REMARKS

Claims 1-31 are currently pending. Figure 4 is proposed to be amended as suggested by the Examiner. Applicants respectfully submit that entry of this Amendment is proper because it places the application in condition for allowance, or at least in better form for appeal. The allowance of claims 1-29 and indication of allowable subject matter in claim 31 are acknowledged with appreciation. Reconsideration is respectfully requested.

Fig. 4 CONVENTIONAL

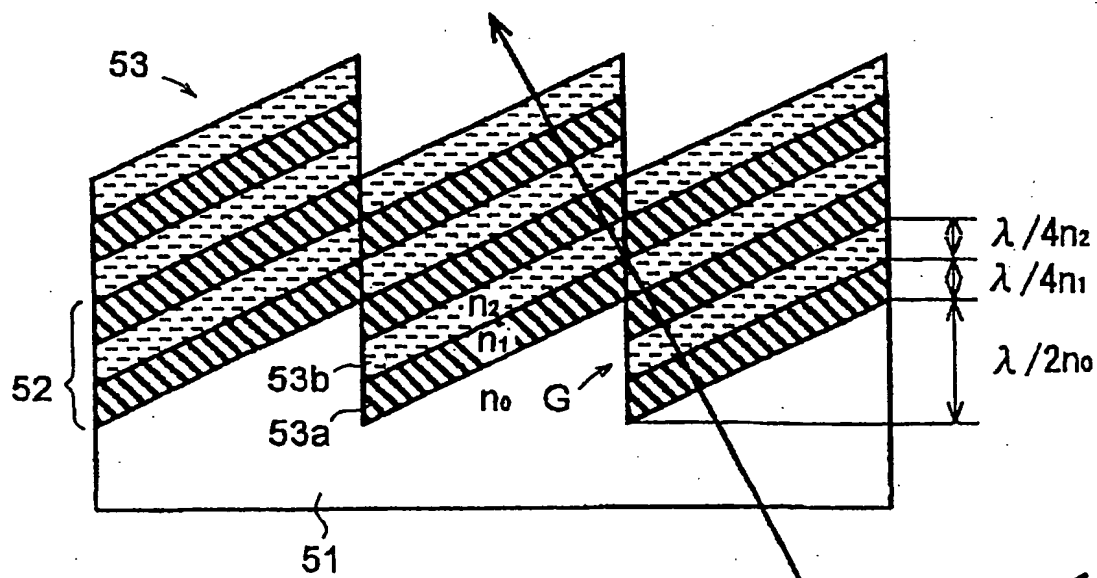
The Office Action includes an objection to Figure 4. Figure 4 is proposed to be amended to include the legend "Conventional" consistent with the Examiner's suggestion. Withdrawal of the rejection is respectfully requested.
